**National Park Service  
U.S. Department of the Interior**

**Mount Rainier National Park  
Regions 8, 9, 10 and 12**

**FINDING OF NO SIGNIFICANT IMPACT  
Fryingpan Creek Bridge Replacement**

Figure 3. Current Conditions in the Project Area / Alternative A – No Action

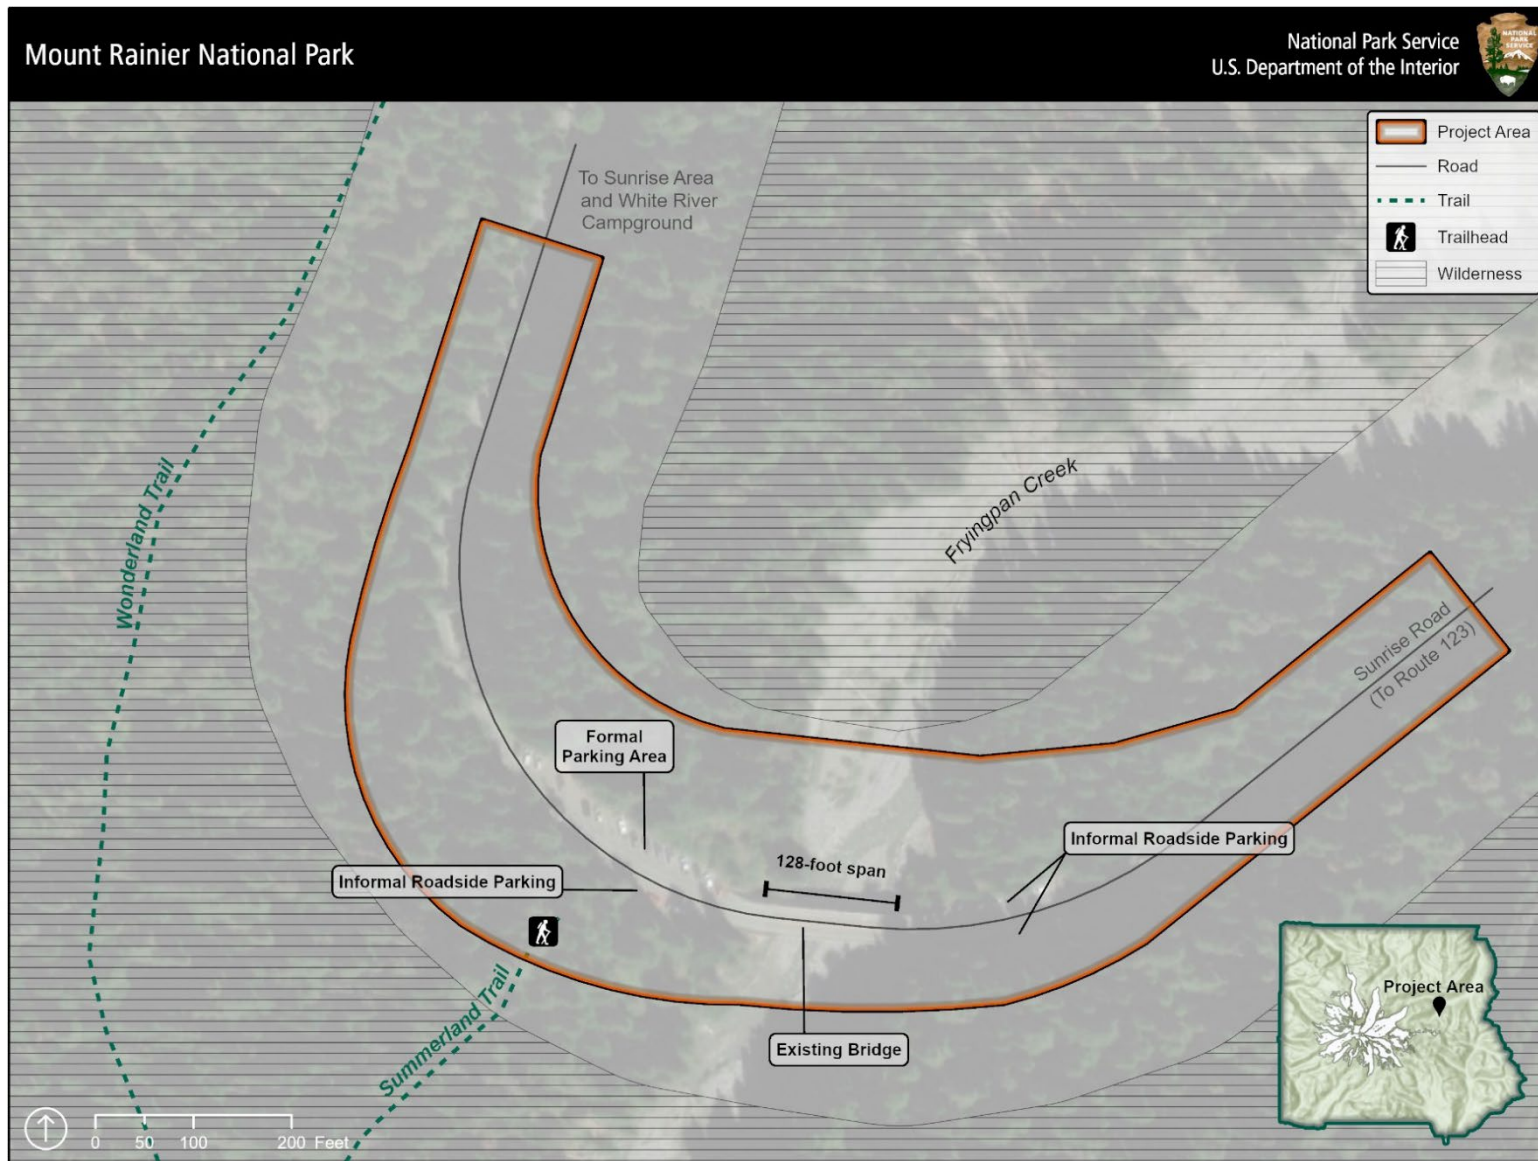
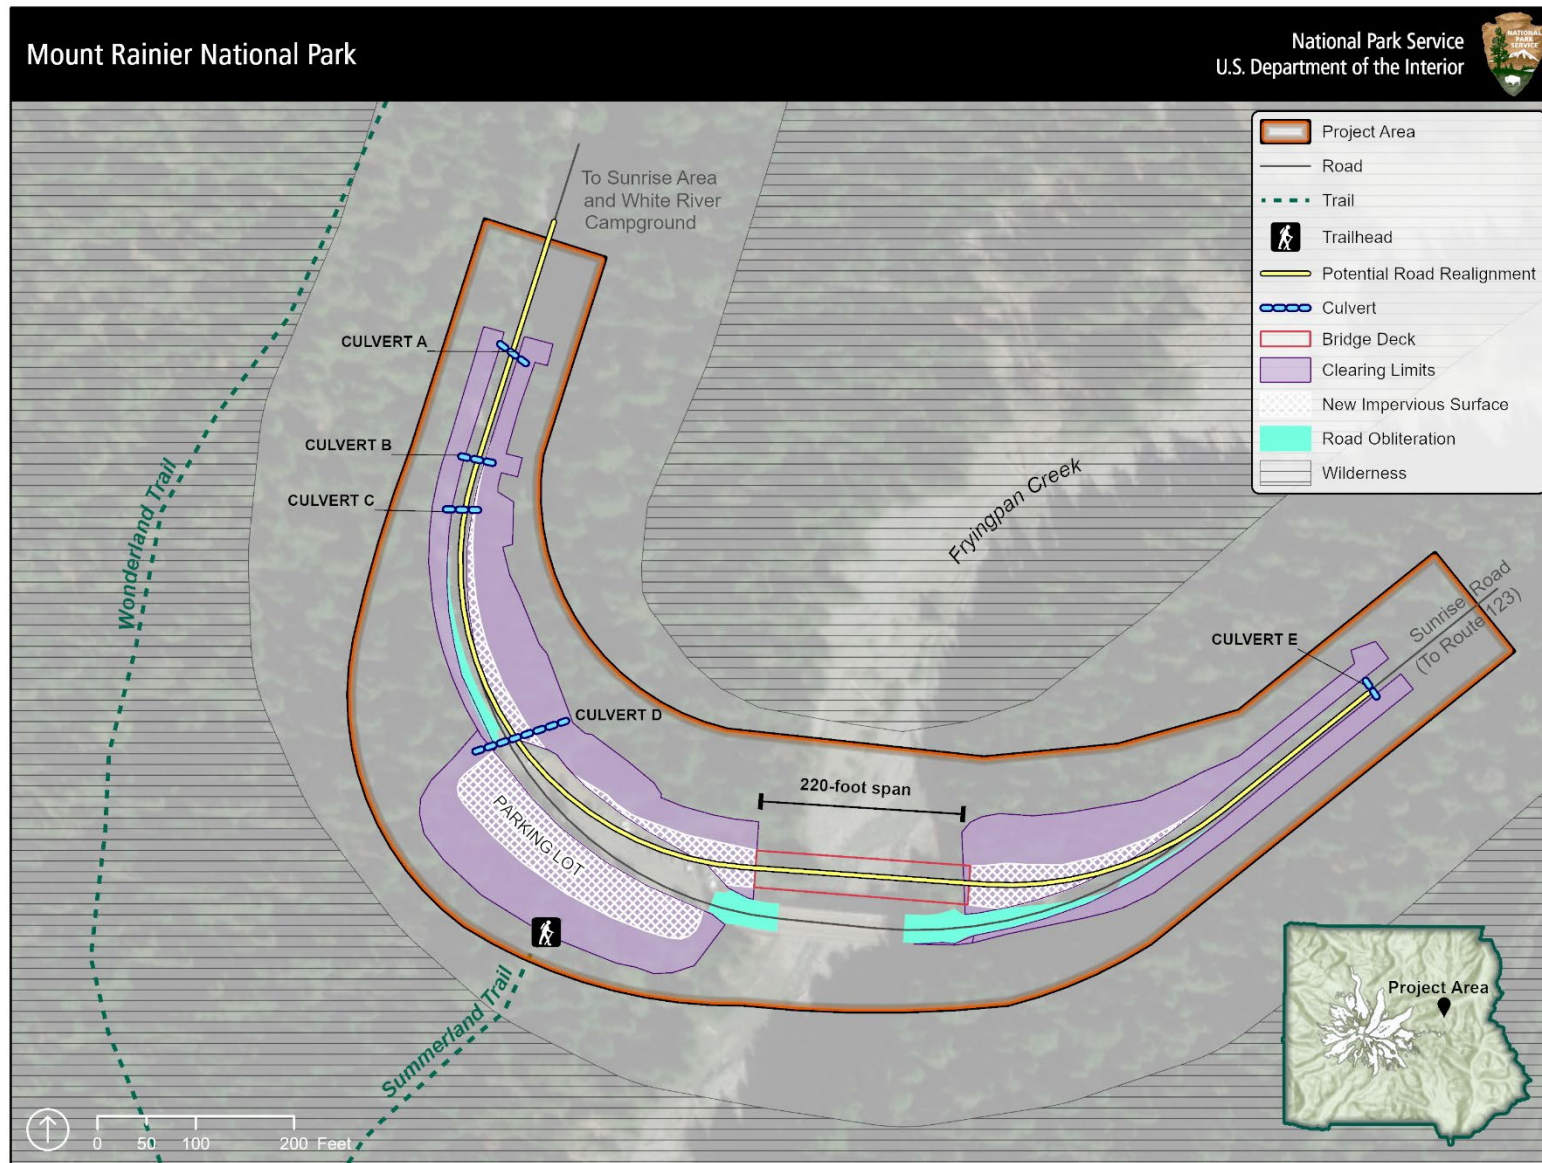
These figures were updated to add the Wilderness boundary.

**Concern Statement:** The figures in the EA should show the wilderness boundary in relationship to the alternatives, and the document should note the distance of the existing road and bridge to the wilderness boundary, as well as whether the infrastructure under either of the action alternatives would encroach on designated wilderness.

**NPS/FHWA Response:** Revised figures showing the wilderness boundary are added in the errata to illustrate the alternative locations in relationship to the boundary. The figures showing the alternatives have been revised to show the wilderness boundary and are included in the errata.

**Figure 5. Rendering of New Bridge under Alternative B/Proposed Action/Preferred Alternative – New Bridge on a New Alignment Downstream of Existing Bridge**

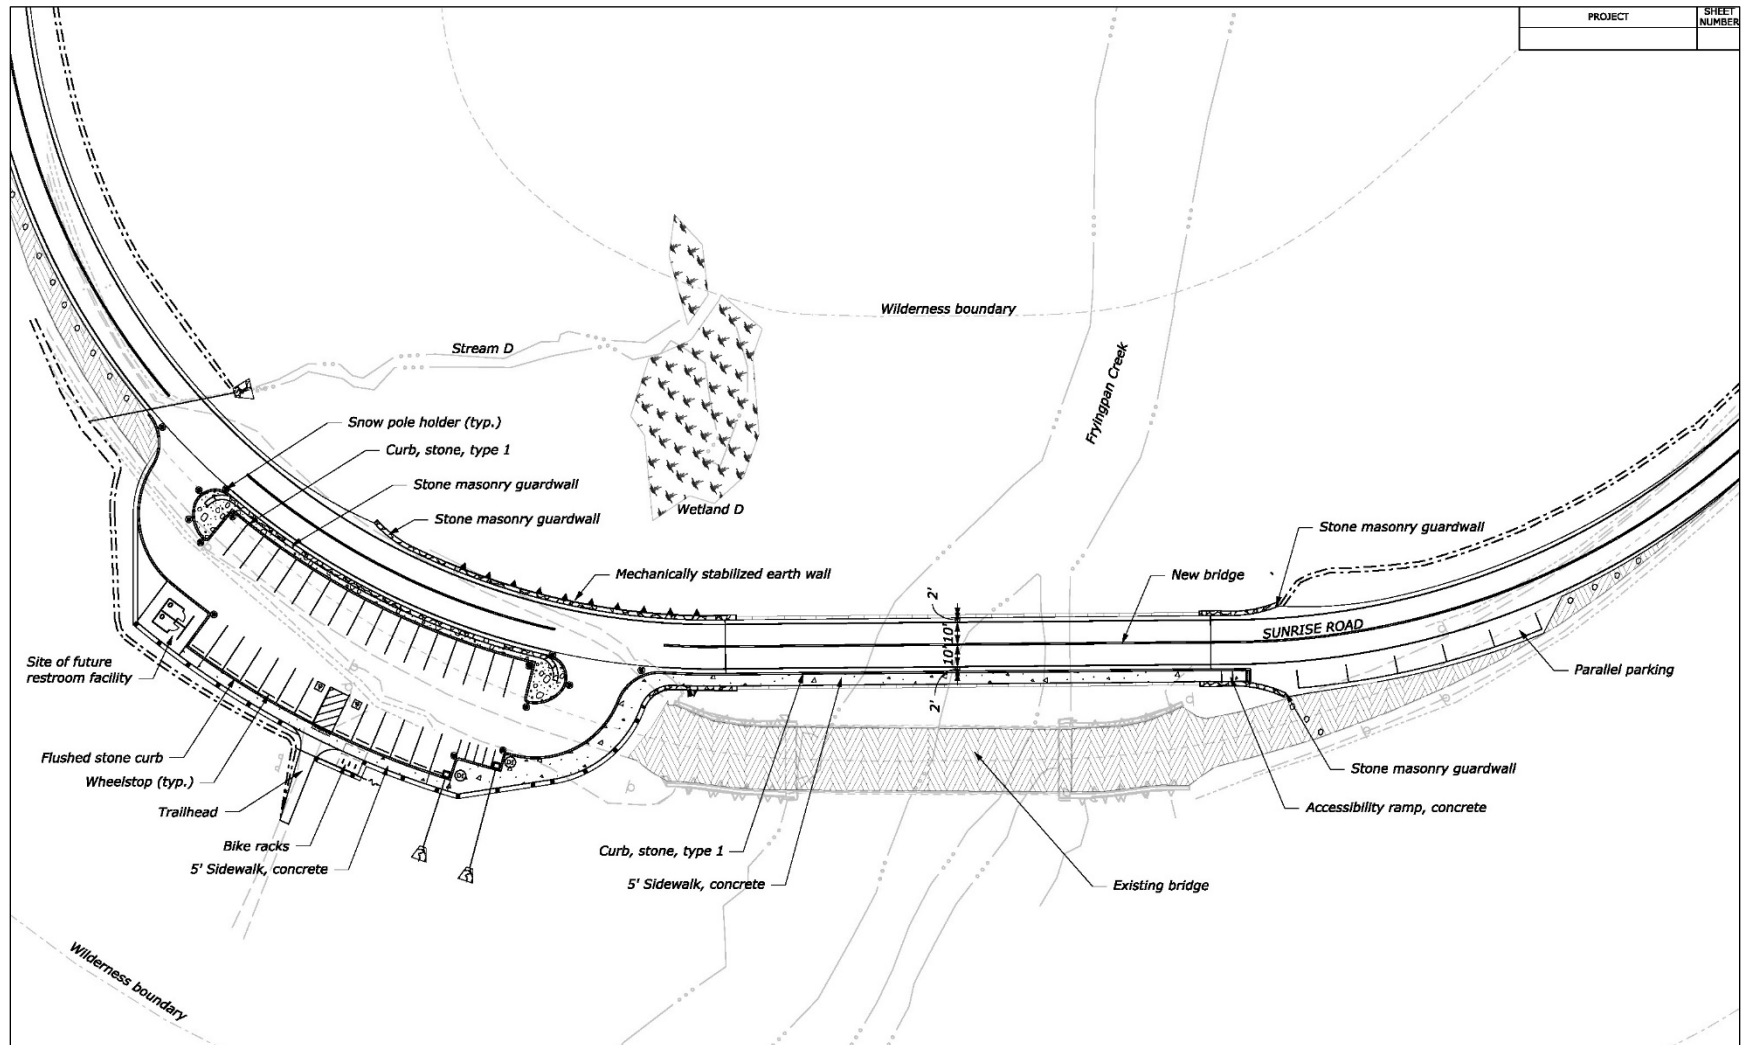
This rendering of alternative B was updated to incorporate additional design details in response to agency consultation and public comment, particularly related to the trailhead and parking lot.

Figure 6a. Additional Trailheads and Trail Spurs to Wonderland Trail

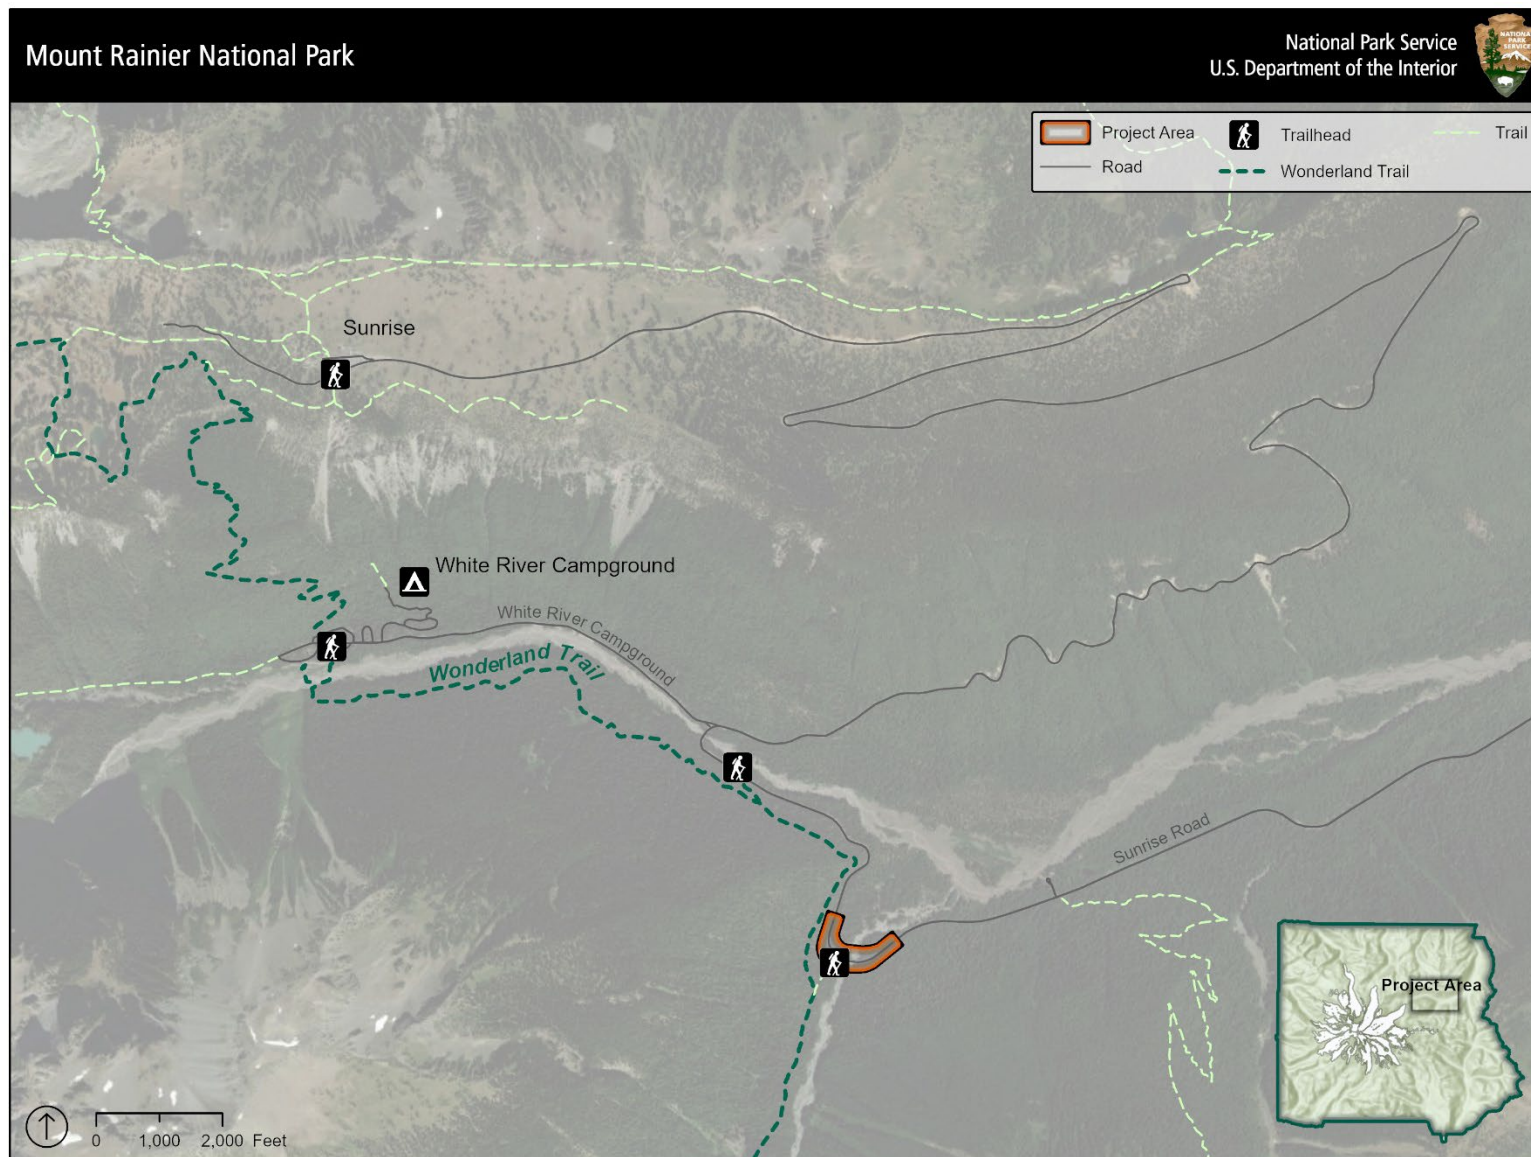
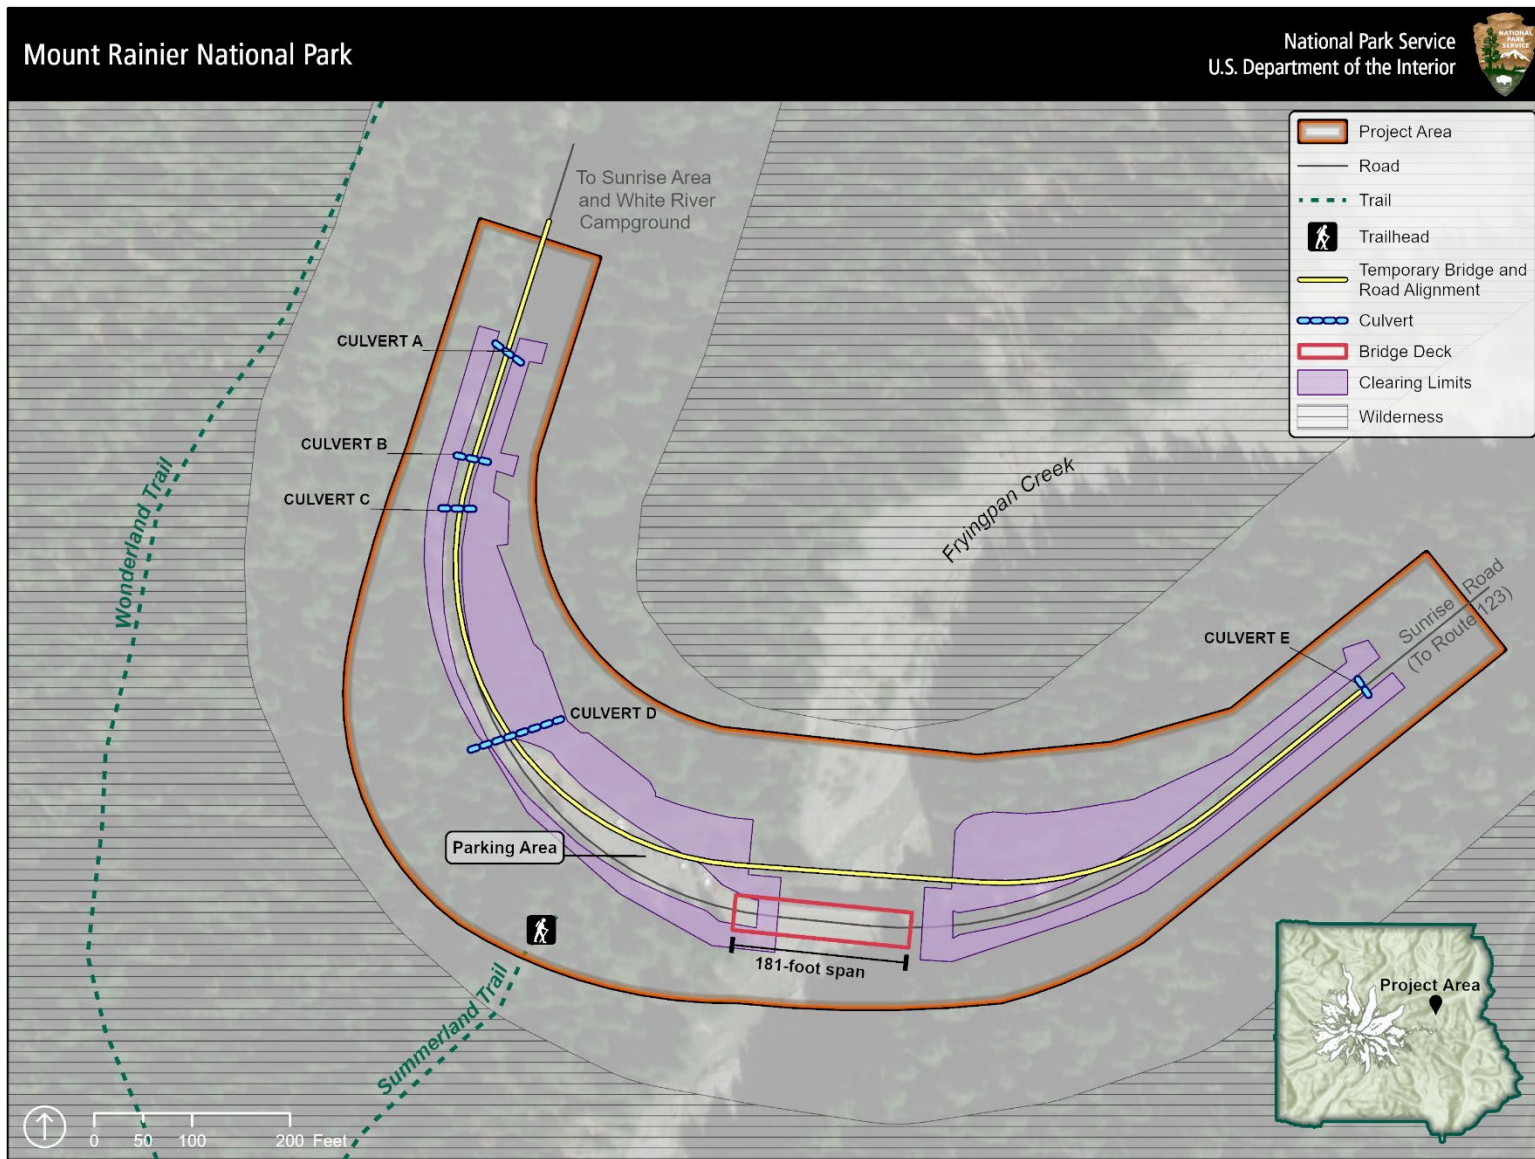
The closest alternate access to the Wonderland Trail is the roadside access on Sunrise Road approximately 0.75 mile to the northwest of the Summerland Trailhead and 1,000 feet before the White River Campground entrance. Additional trailheads and trail spurs are shown in figure 6a.
